Subject: UNUSUAL STEERING NOISE AND / OR VIBRATION WHEN TURNING	Bulletin No: 06-002/16
	Last Issued: 04/29/2016

2016 Mazda2 vehicles with VINs lower than 3MD DJ ***** 106153 (produced before January 18, 2016)

2016 CX-3 vehicles with VINs lower than JM1 DK ***** 133287 (produced before January 21, 2016)

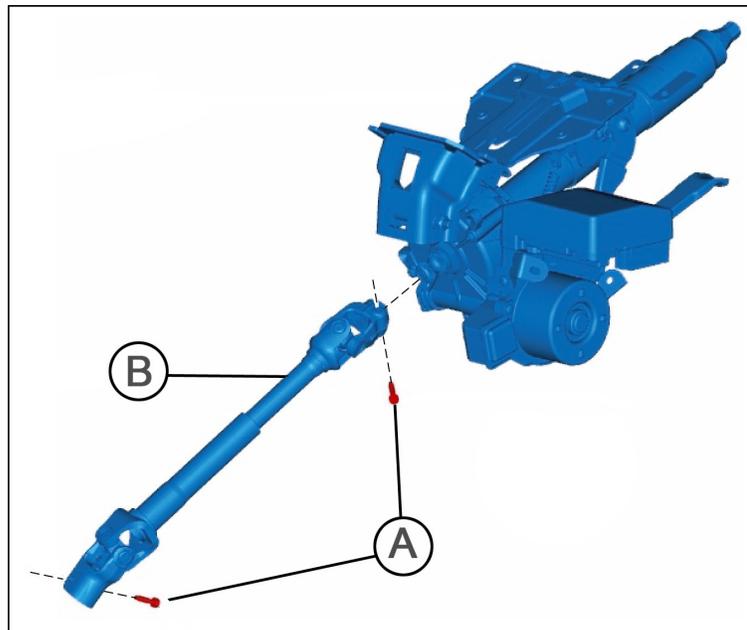
Some vehicles may exhibit an unusual noise from around the driver's foot area when repeatedly turning the steering wheel to the left or right. A vibration is felt at the steering wheel when the noise occurs.

1. Verify customer concern.
2. Replace the intermediate shaft (B). Refer to MS3 online "INTERMEDIATE SHAFT REMOVAL/INSTALLATION".

NOTE: Replace joint bolts A (Replacement part) with new ones.

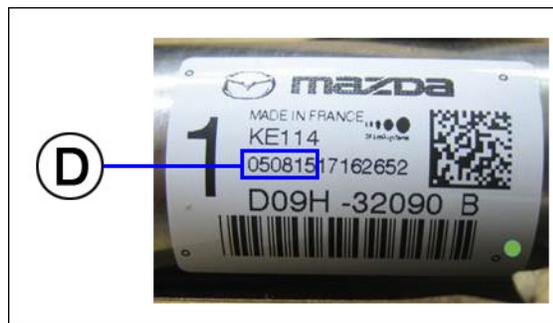
The intermediate shafts with the production date after October 28, 2015 are modified.

The image shows a production date of August 5, 2015 (D) as an example.
